Submission on the Environmental Impact Statement (EIS) – Coffs Harbour Bypass

Application No. SSI-7666

The attached feedback is provided as a result of a Coffs Harbour City Council technical review in response to the *Environmental Impact Statement (EIS)* for the Coffs Harbour Bypass, September 2019.

FIG 5.21 TYPICAL SECTION THROUGH RETAINING WALL WITH ADJACENT PLANTING

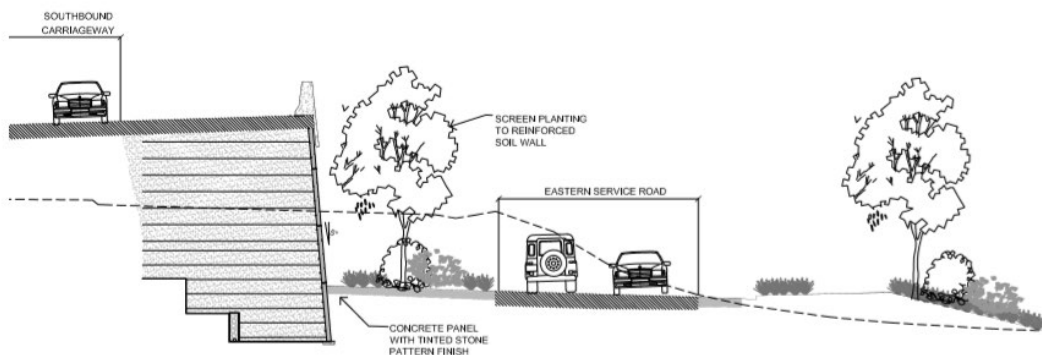
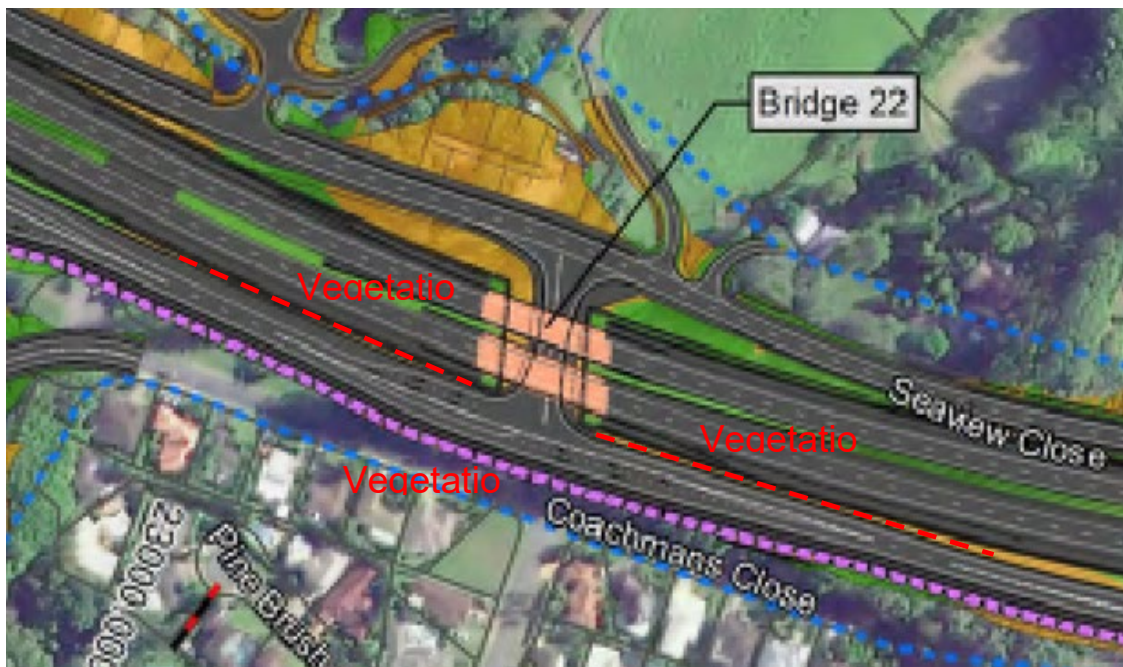
Visual viewpoints created for the project show the project fitting in seamlessly in surrounding areas, which for the most part is true. Viewpoint 2 selected at the entrance to Coachmans Close is noted as having a high magnitude visual disruption. However, there is no enhanced image to show the magnitude of the highway retaining wall in this location. At present the location fronts directly to the existing highway. This will be replaced by a 4-5m high retaining wall + noise screening height.

Additionally, the roadway at Coachmans Close currently has significant screening from dense trees which provides residents a visual screen to the highway and a sense of seclusion.

The intention in this area as far as CHCC can determine from the plan views is that this will be removed to enable the extension of Solitary Islands way and the underpass to the Western Access Road. This will result in views of the 8.3m and 9.0m high retaining walls. RMS note that screen planting will be placed at this location however space appears very constrained and CHCC are concerned vegetation will be omitted.

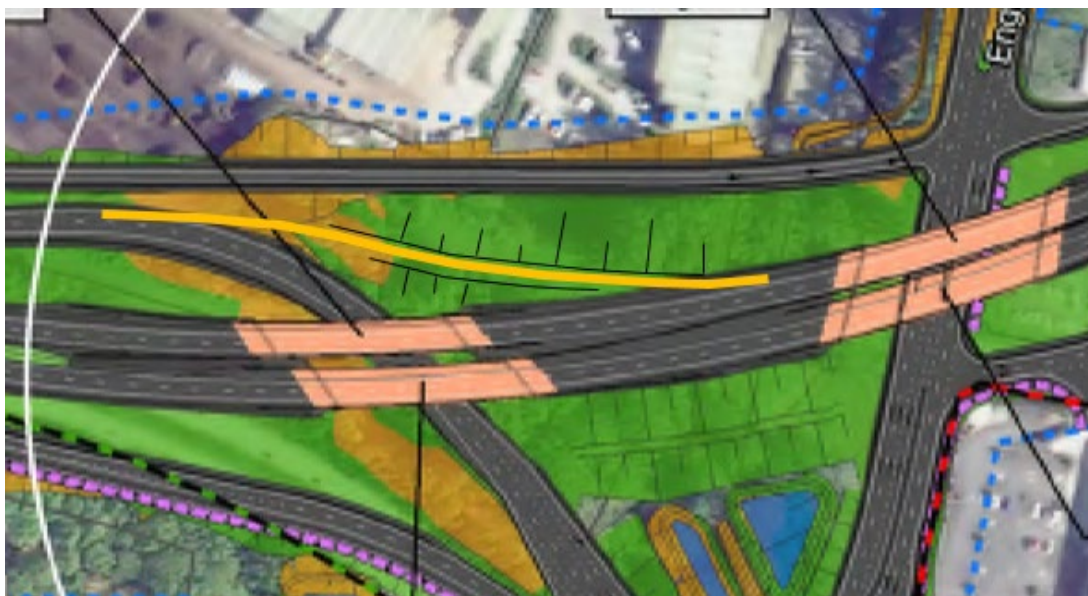
CHCC previous have identified that a western service road connecting to the Sawtell Road Intersection instead of Englands Road would bring considerable benefits in minimising conflicts with the waste facility land. By doing this, this would require an upgrade of the Sawtell Road interchange, which is a future priority for RMS. It also brings considerable benefits to the local community in crash reduction.

Ultimately CHCC desire an outcome which minimises impact to the waste facility and maximises the road safety of all users. CHCC believe the current solution is not holistic in considering all of the issues raised in the area and request RMS consider a solution that helps solve future priorities and the local community.

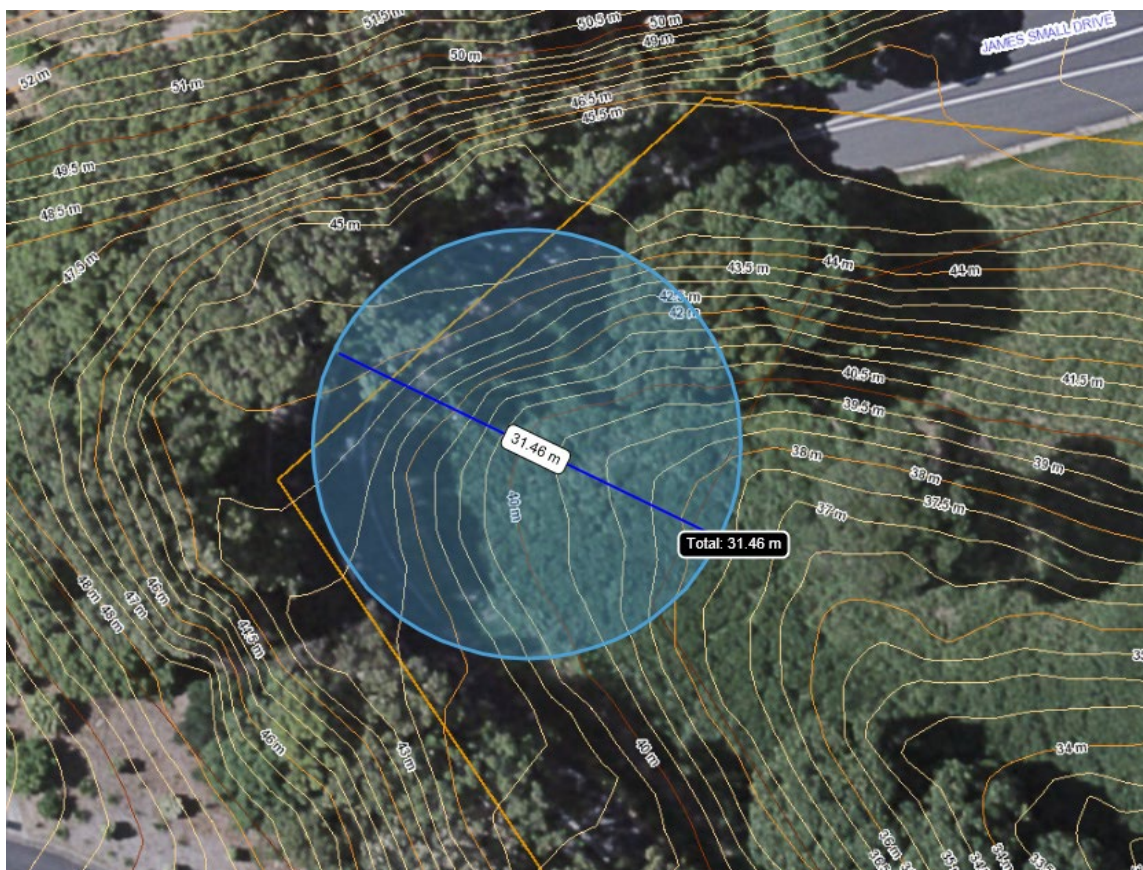
CHCC have previously expressed concerns regarding the change in use of James Small Drive as a result of the Korora Bus Bay alteration. Concerns with the proposed arrangement are:

- Sub-standard curves and other features
- Bus Increases on James Small Drive
- Flooding on James Small Drive

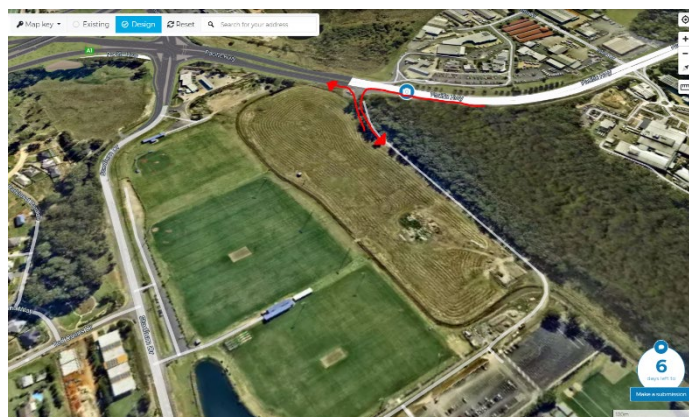
The performance of the Pacific Highway / Isles Drive intersection is reported to provide a current overall Level of Service (LOS) of 'C' for AM period, and 'D' for PM period with a LOS of 'E' for the worst movements (east and west approaches). The modelled 2044 intersection

LOS is similar for overall performance ('D' for AM period, and 'C' for PM period) but the worst movement LOS degrades to a level 'F' - unsatisfactory as described in Section 3.5 of EIS Volume 3 – Appendix F.

Recommendation: The Pacific Highway / Isles Drive intersection needs to be improved to provide a LOS higher than 'F' for the worst movement. It is noted this should be done in consultation with CHCC together with the proposed modifications to permit B-doubles to access Isles Drive (Section 5.2 of EIS Volume 3 – Appendix F).
